**DATE: May 20, 2024**  
**TO: Planning Board**  
**FROM: Lichuan Wang, P. E., C. M. E.**  
**SUBJECT: Harborside 9**  
**242 Hudson Street, 3 Second Street & Harborside Place**  
**Block 11603, Lots 18.02, 18.03, 22, 27**

This site plan review is based upon plans submitted by Matthew J. Neuls, P.E. of Dresdner Robin located in Jersey City, NJ 07302.

DRAWING NUMBER:  
C14182-DWG06

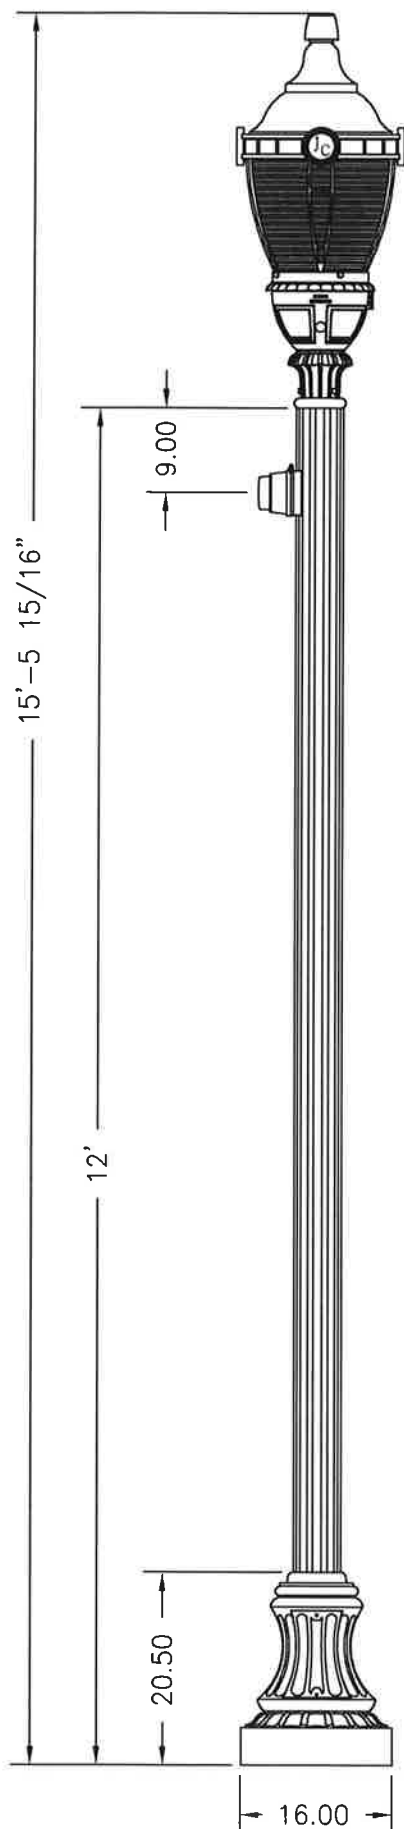
**Construction Notes & Details, Sheet C-901:**
